HISTORIC AND DESIGN REVIEW COMMISSION

April 05, 2023

HDRC CASE NO: 2023-103
ADDRESS: 918 N PINE ST
LEGAL DESCRIPTION: NCB 1653 BLK A LOT 4 AT 918 PINE N
ZONING: R-5 CD, H
CITY COUNCIL DIST.: 2
DISTRICT: Dignowity Hill Historic District
APPLICANT: David Ericsson/Pine Bureau
OWNER: David Ericsson/Pine Bureau
TYPE OF WORK: Construction of a carport, construction of a site wall, landscaping
APPLICATION RECEIVED: March 17, 2023
60-DAY REVIEW: Not applicable due to City Council Emergency Orders
CASE MANAGER: Edward Hall

② Carport Axon _ 1/16

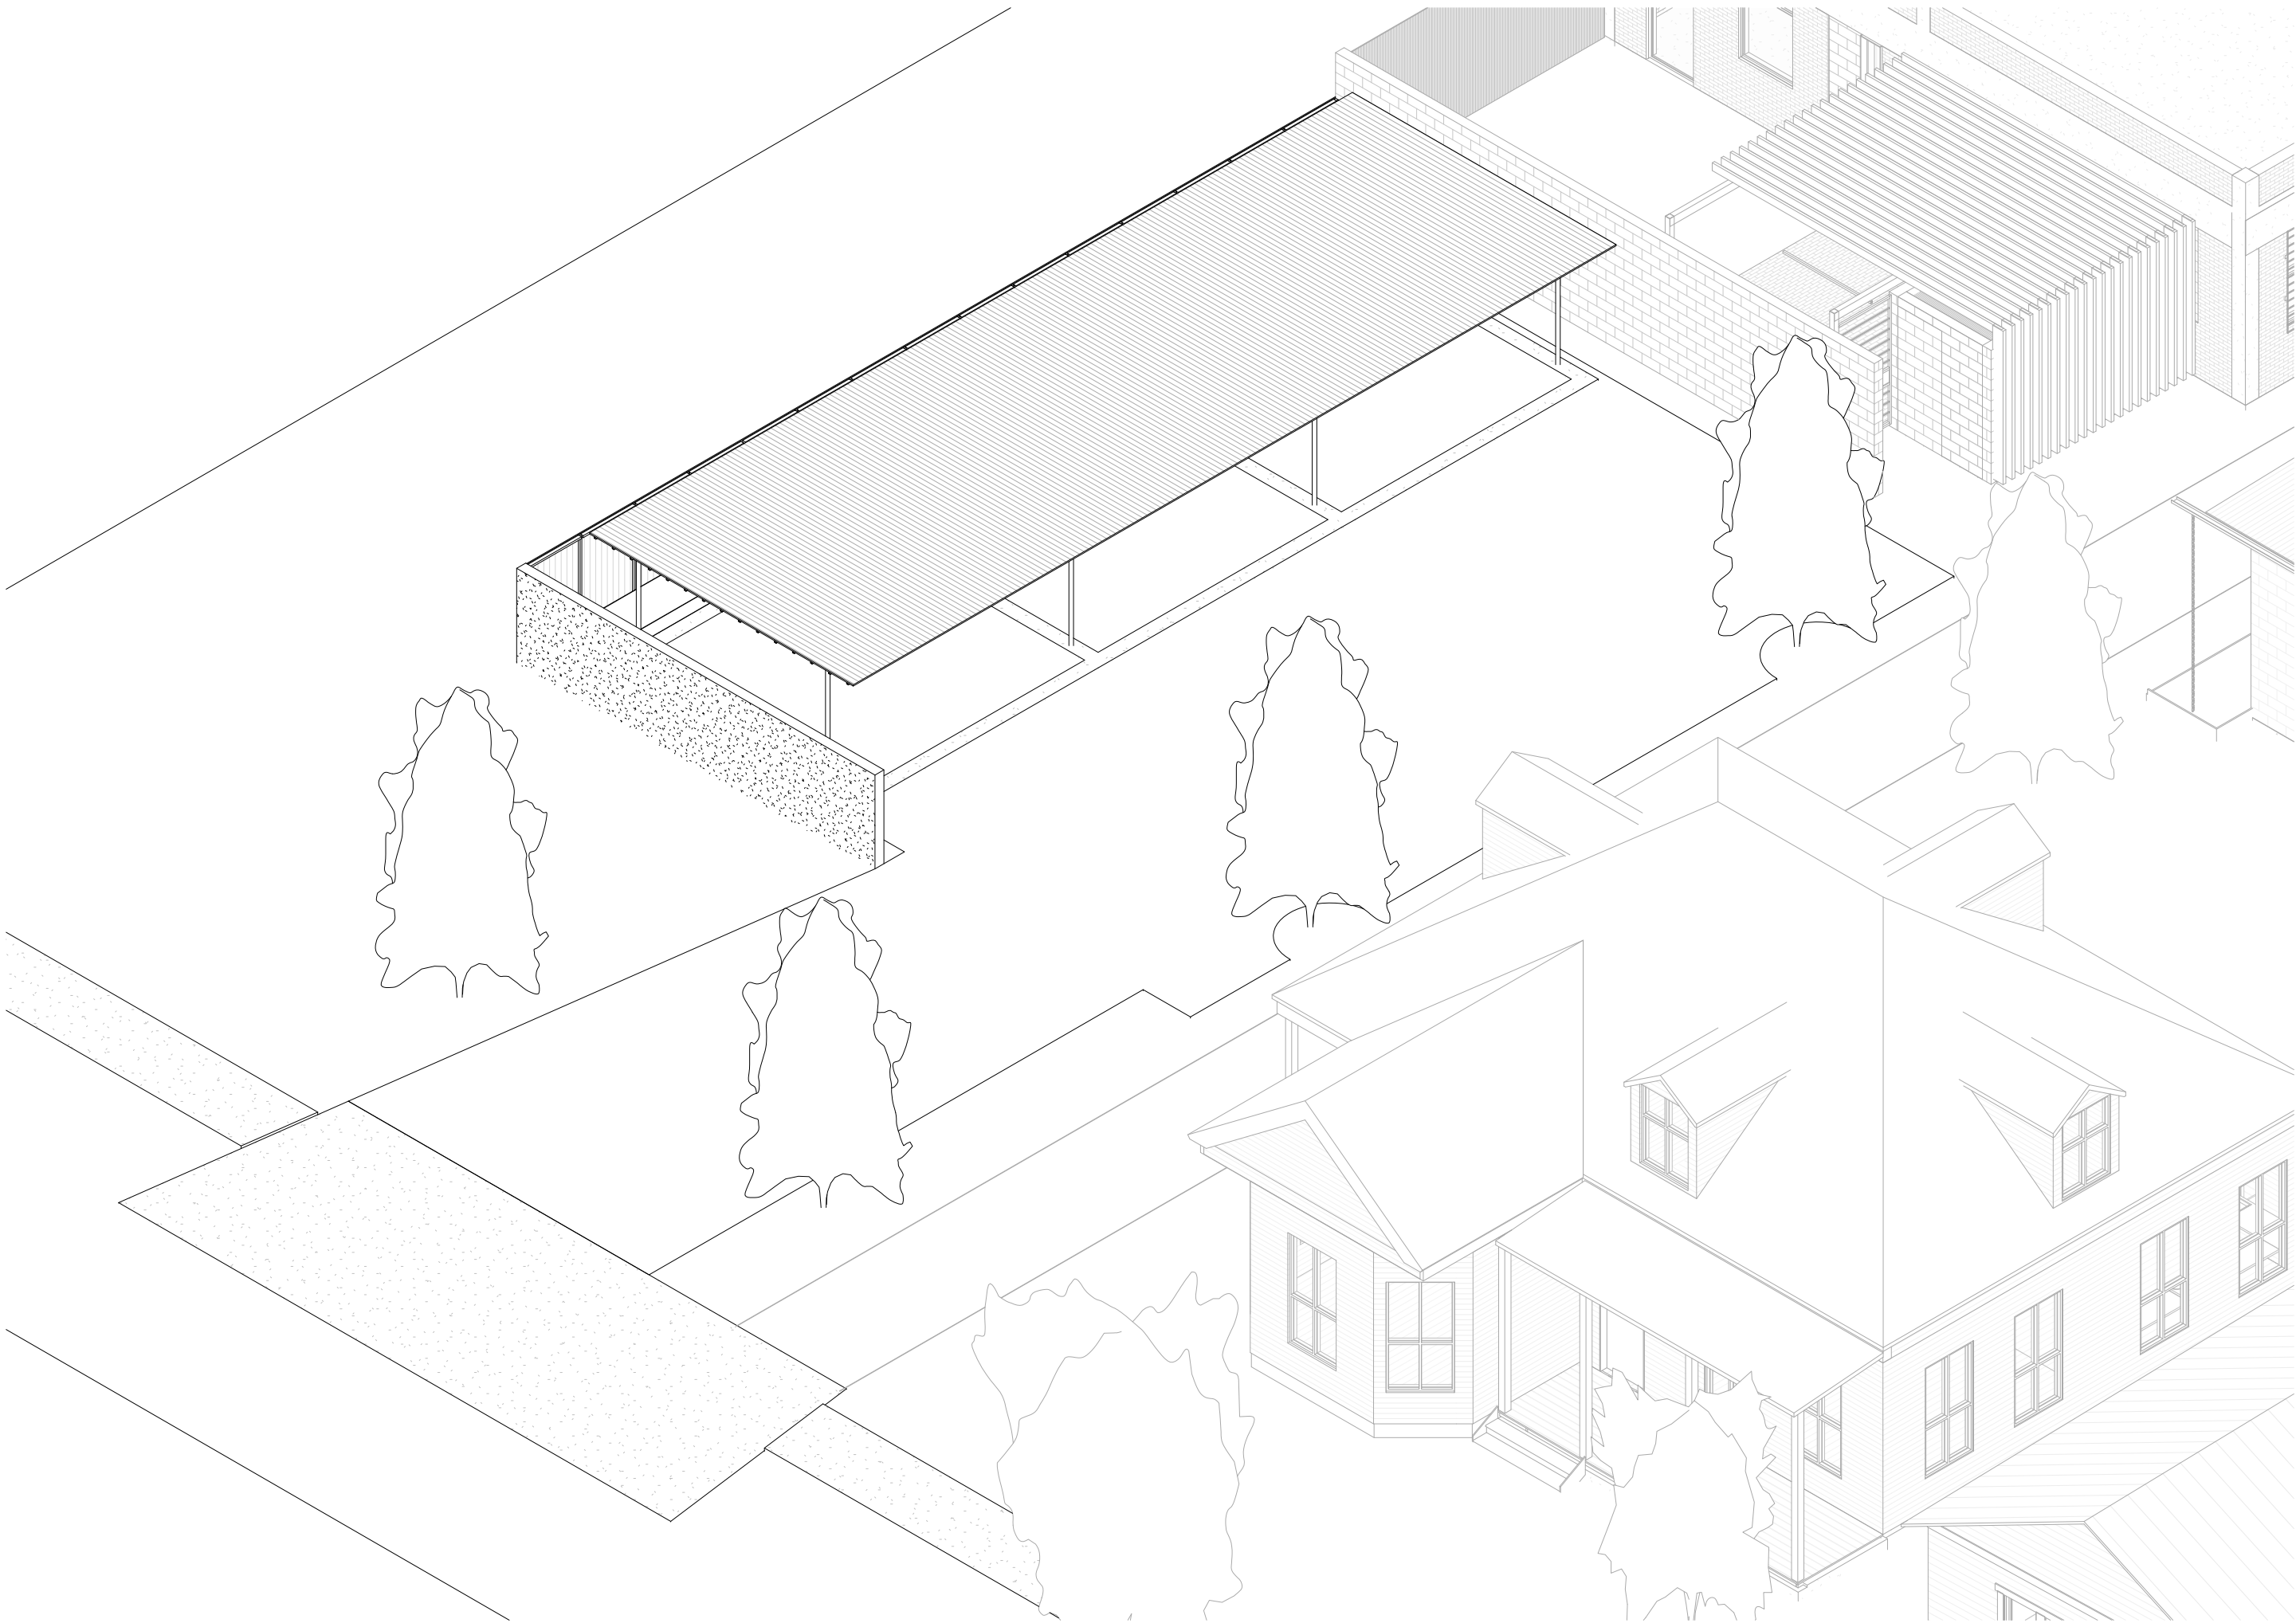
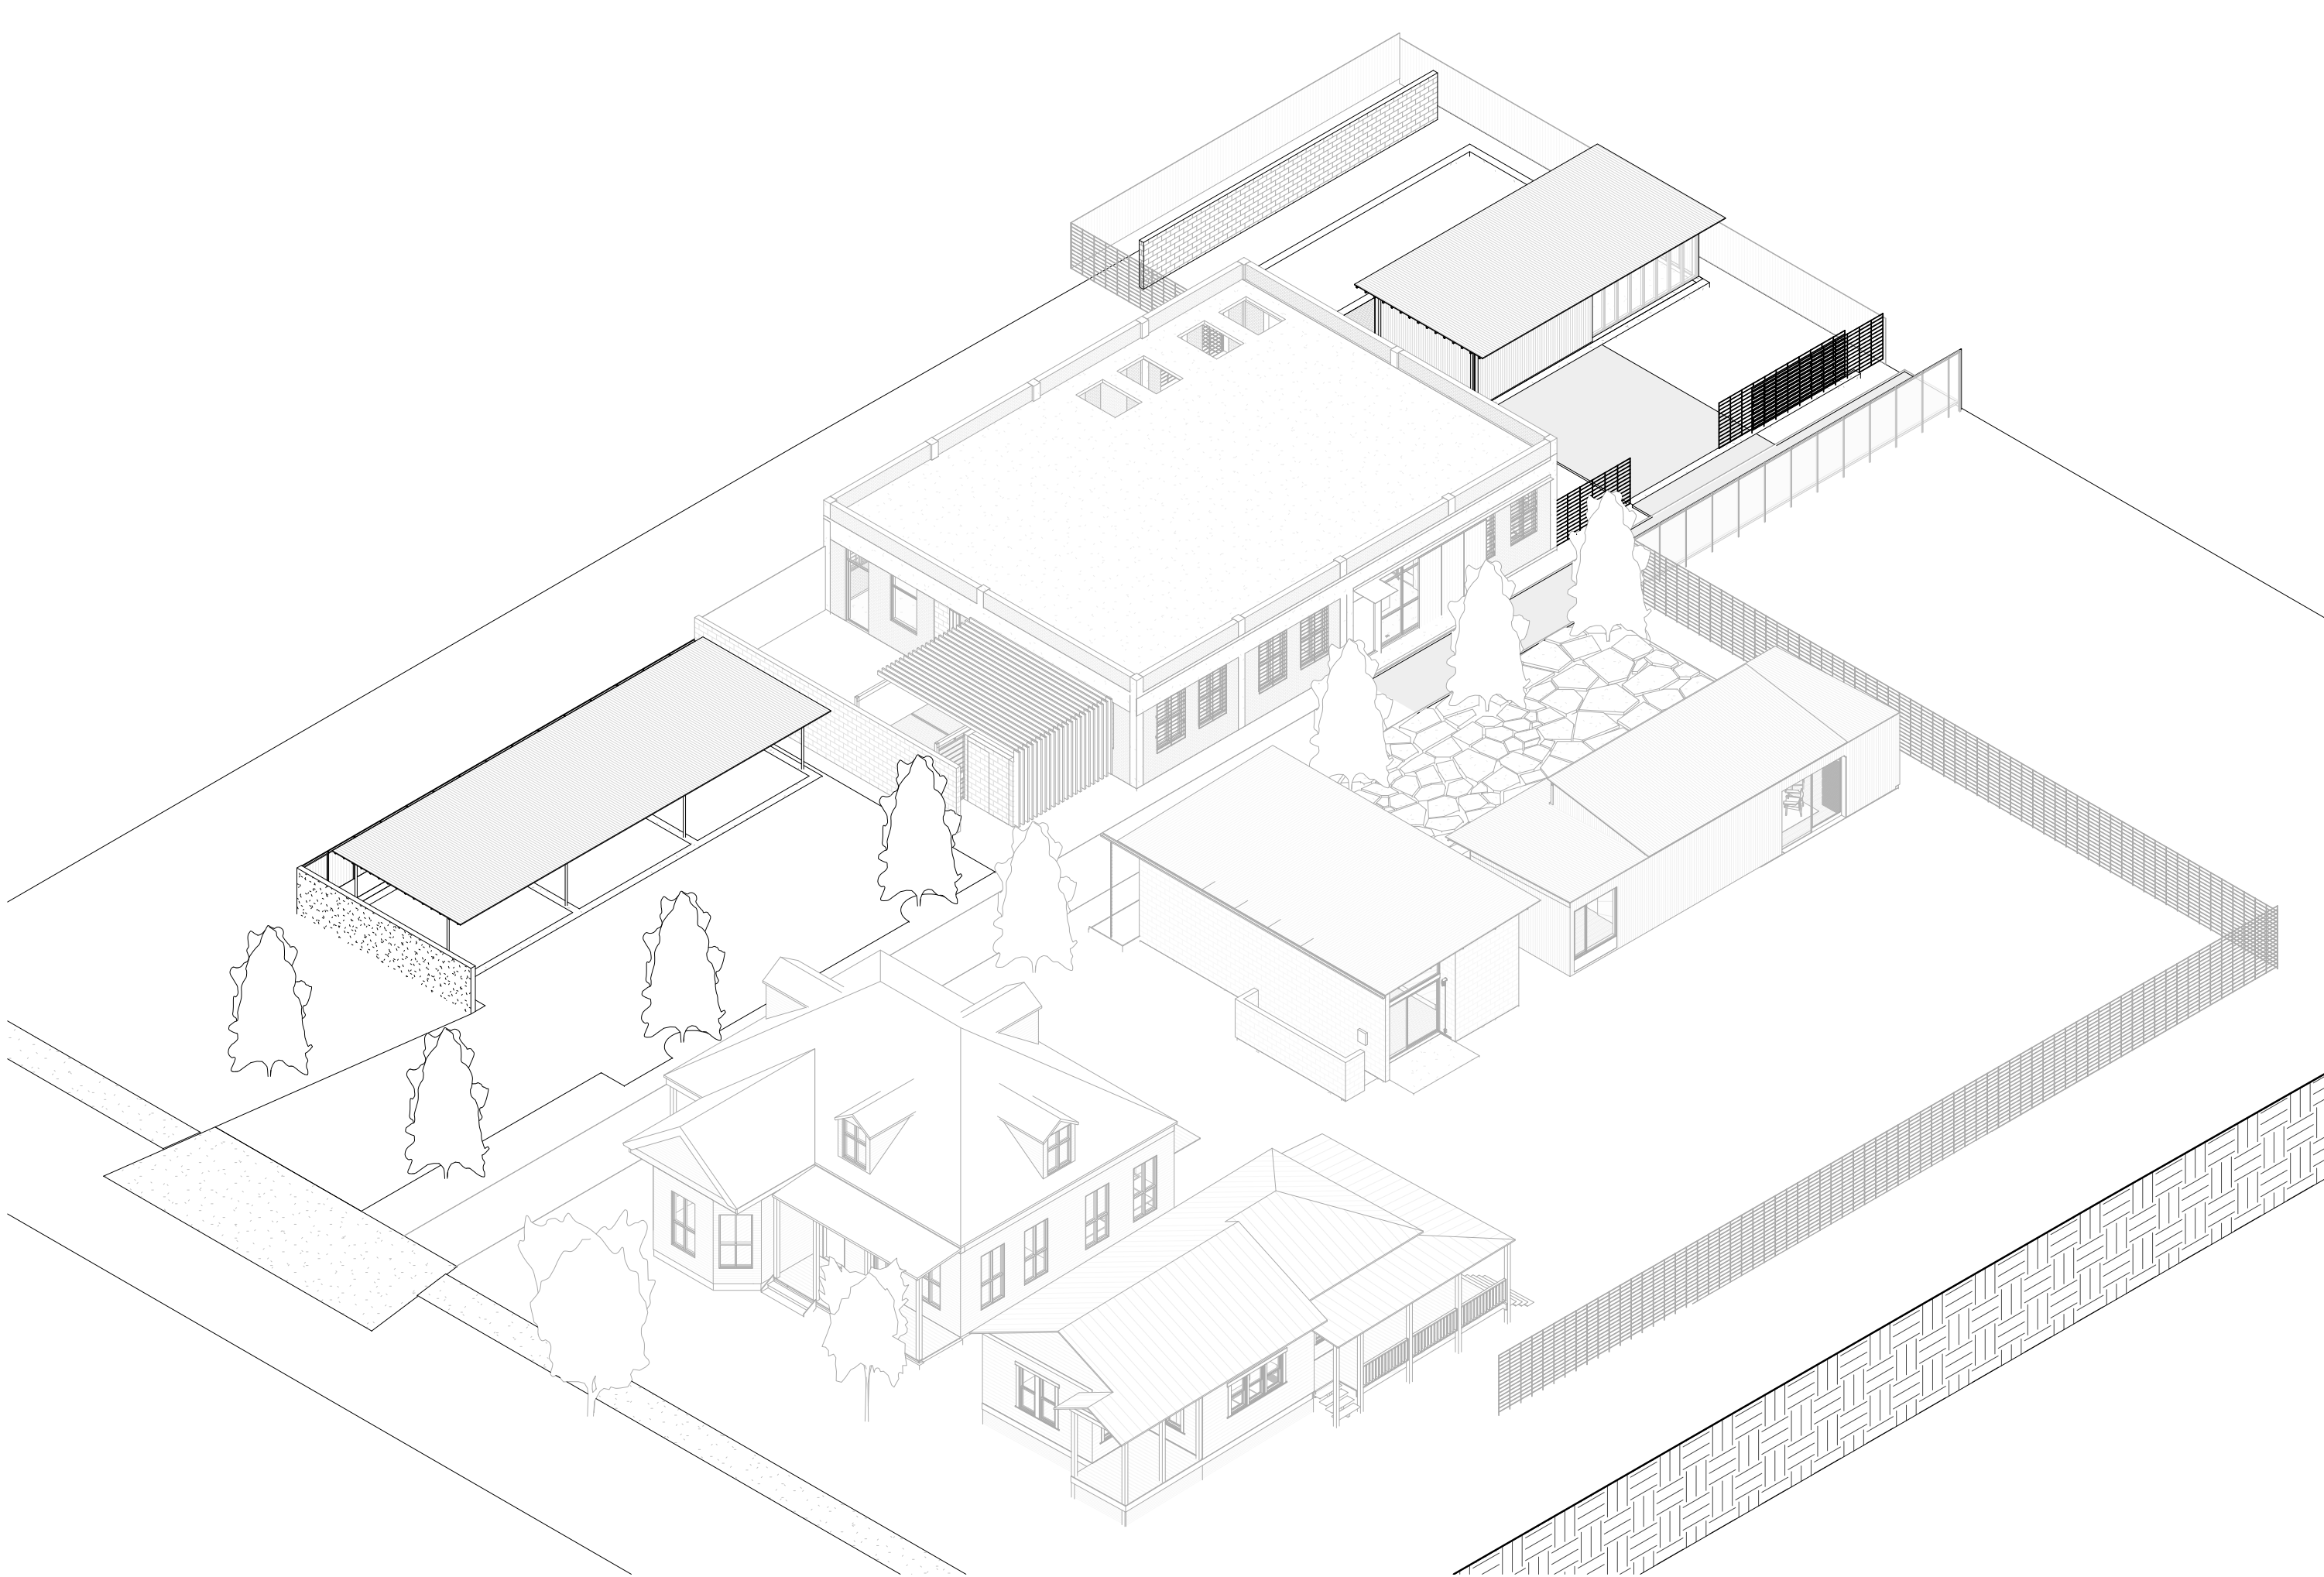
- e. CARPORT (Massing & Form) – The applicant has proposed to construct a steel carport structure to feature an overall length of 56' – 0", an overall depth of approximately 20' – 0" and an overall height of 8' – 7". The proposed carport will be location in a position that would occupy space former occupied by a historic structure. The Guidelines for New Construction 5. Notes that new garages and outbuildings should be designed to be visually subordinate to the primary historic structure on the lot, should be no larger in plan than 40 percent of the primary historic structure's footprint, should relate to the period of construction of the primary historic building on the lot, should be located consistently with the predominant garage and outbuilding orientation on the lot, and should follow the historic setback pattern of the block. Generally, staff finds the increased setback to be appropriate and finds the overall construction of the carport to be appropriate.

- f. WALL – The applicant has proposed to construct a solid wall that is to run parallel to N Pine Street to screen the proposed parking from view from the right of way. The applicant has proposed for the wall to feature six (6) feet in height. The Guidelines for Site Elements 2.B.i. notes that new fences and walls should appear similar to those used historically within the district regarding transparency, scale and character, should be located where historically found, should be limited to four (4) feet in height, and should feature traditional fencing materials. Generally, staff finds a solid wall, if located consistently with the neighboring privacy fence to be appropriate. A final wall detail is to be submitted to OHP staff for review and approval.

- 1. Staff recommends approval of item #1, the construction of a carport based on finding e. A setback inspection is to be completed by OHP staff to ensure placement consistent with the HDRC's approval.
- 2. Staff recommends approval of item #2, the construction of a solid wall based on finding f with the following stipulations:
 - i. That the proposed wall be aligned with the neighboring privacy fence.
 - ii. That the proposed wall not exceed six (6) feet in height.
 - iii. That detailed construction documents be submitted for review and approval that note stucco finish and wall detailing.
